**AREA 2 FIELD SAMPLING PLAN**

**ADDENDUM TO REMEDIAL INVESTIGATION**

**FORMER FORT DEVENS ARMY INSTALLATION, DEVENS, MA**

**DECEMBER 2018**

Figure  
6

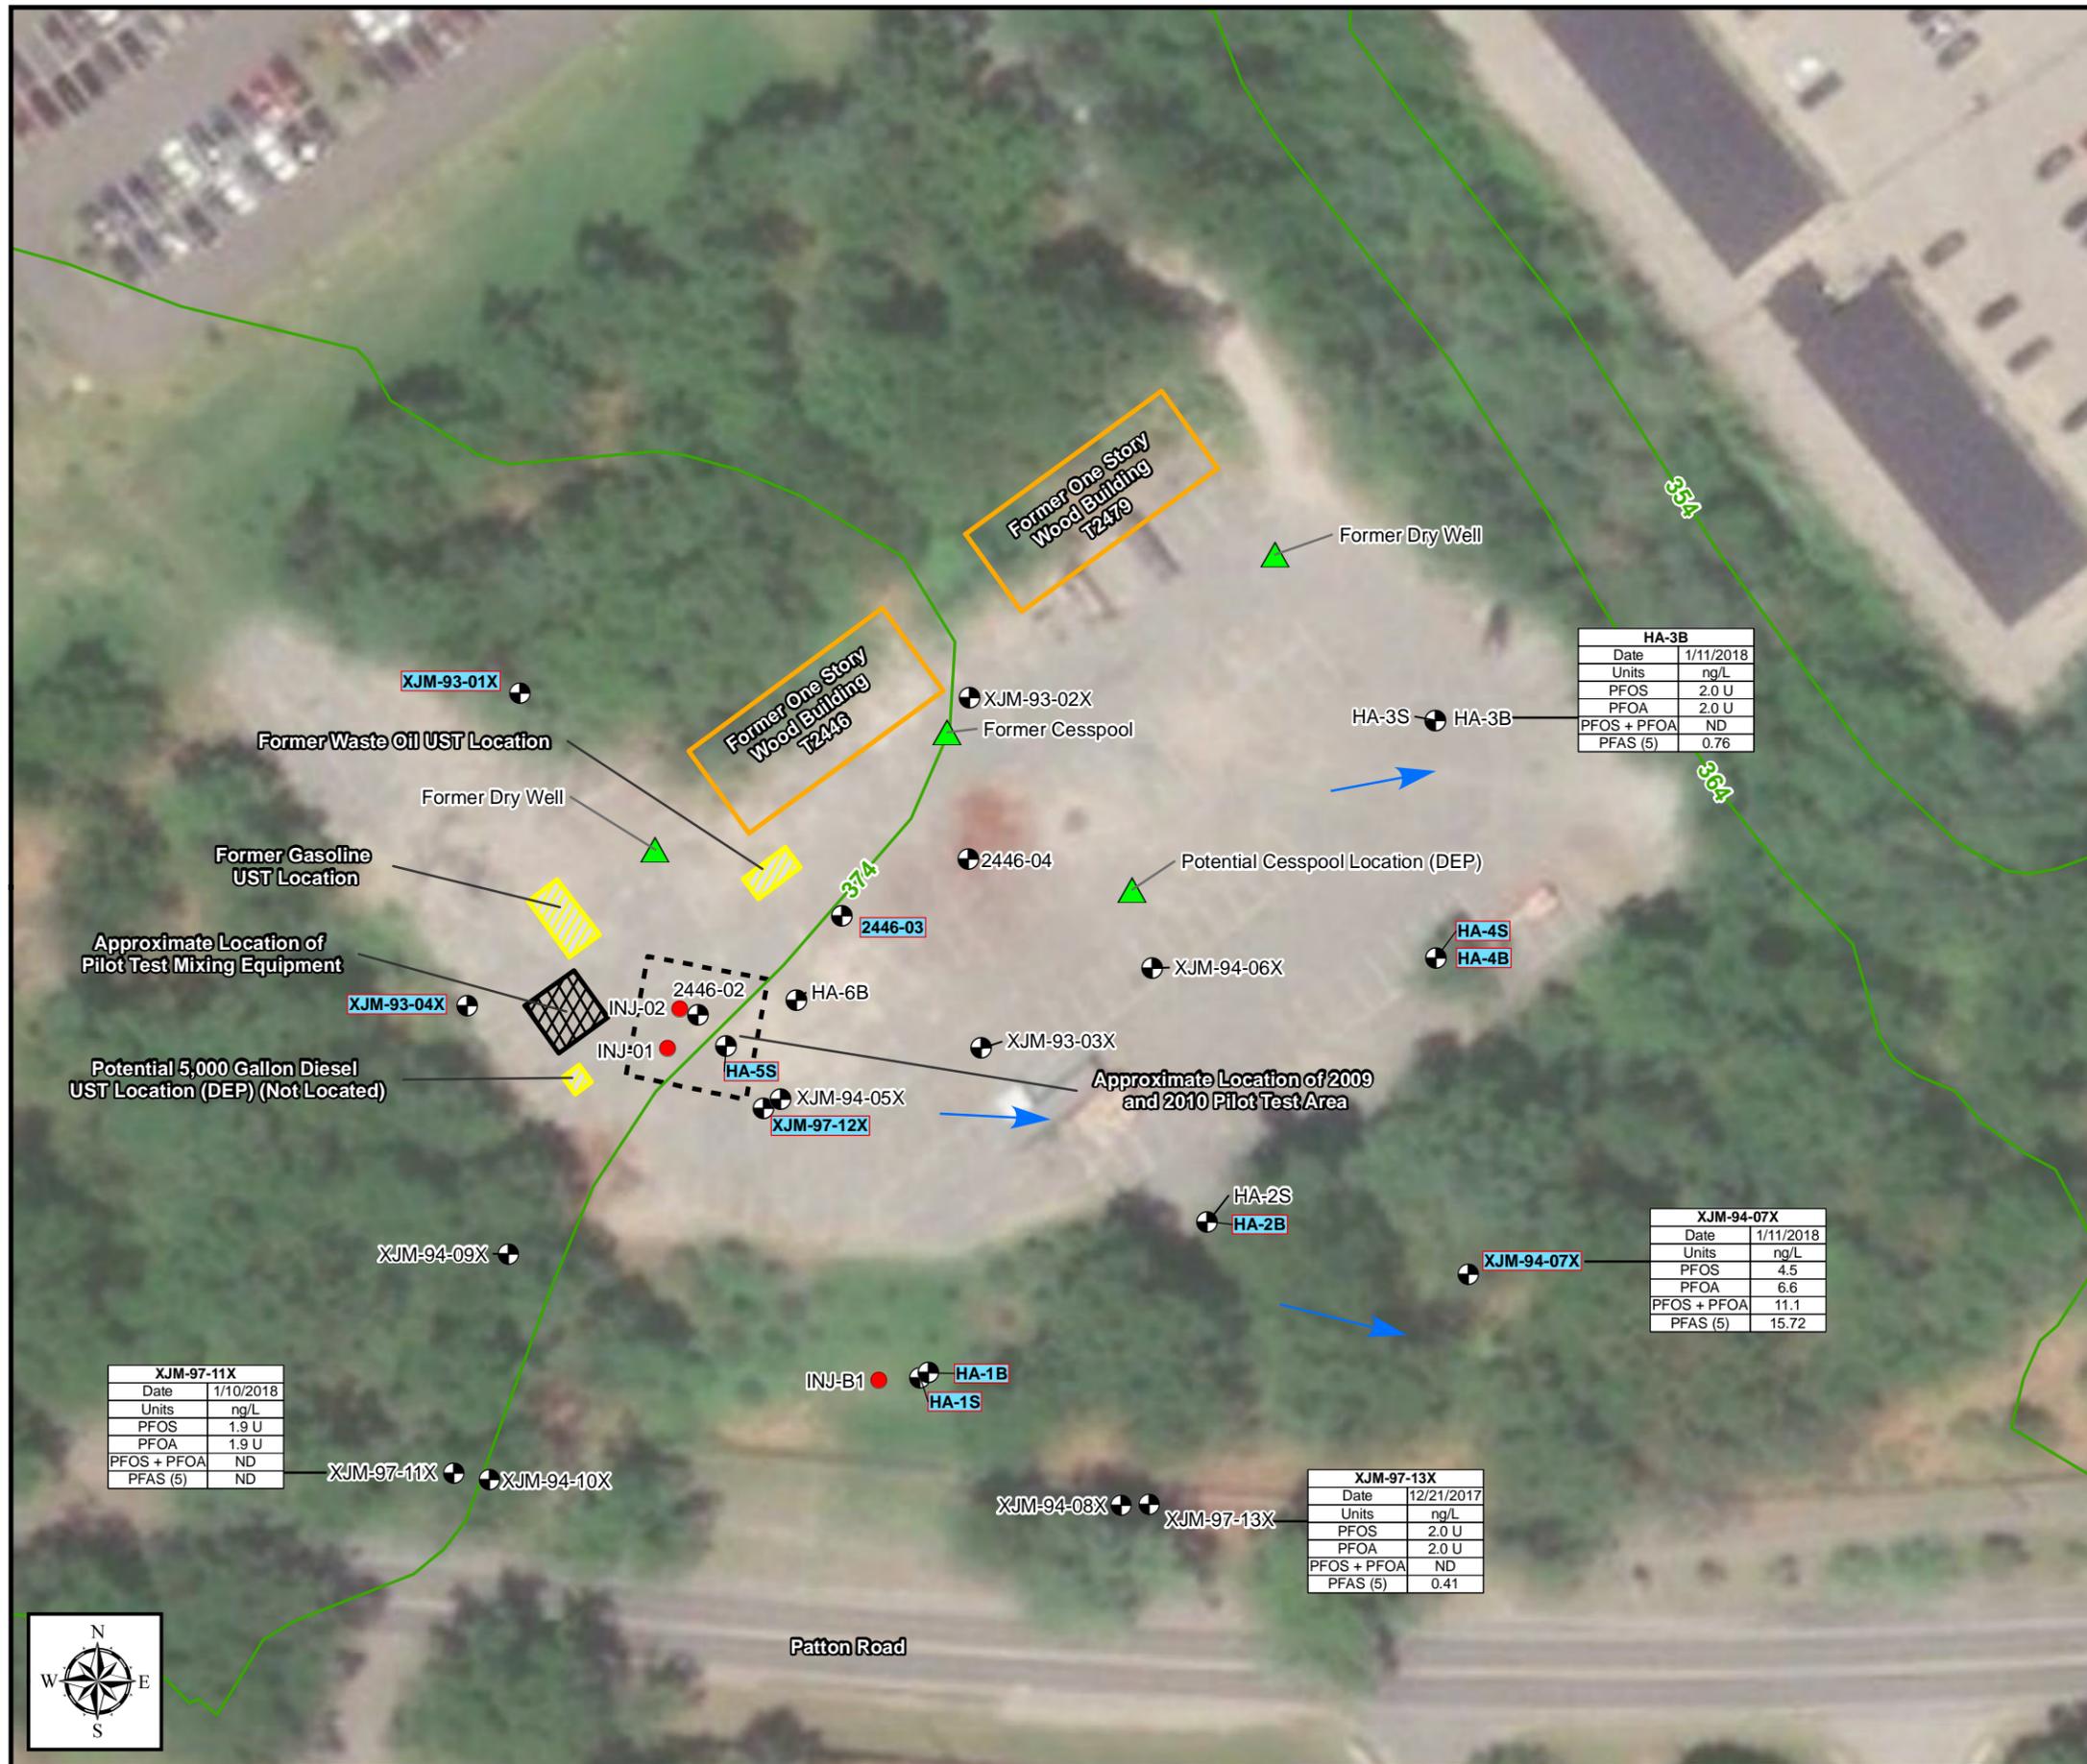
**Comment # 12:** Figure 6, AOC 43G – Another vertical profiling point is needed north of AAFES-7, where PFAS exceeded the LHA, and along Patch Road south of GVP-18-8 in order to define the PFAS plume width at these downgradient locations. Please include an additional vertical profiling point at each of these locations. Also note in Figure 6, “GVP-18-8” should be “43GVP-18-8” for consistency.

**Comment # 12:** Figure 6, AOC 43G – Another vertical profiling point is needed north of AAFES-7, where PFAS exceeded the LHA, and along Patch Road south of GVP-18-8 in order to define the PFAS plume width at these downgradient locations. Please include an additional vertical profiling point at each of these locations. Also note in Figure 6, “GVP-18-8” should be “43GVP-18-8” for consistency.
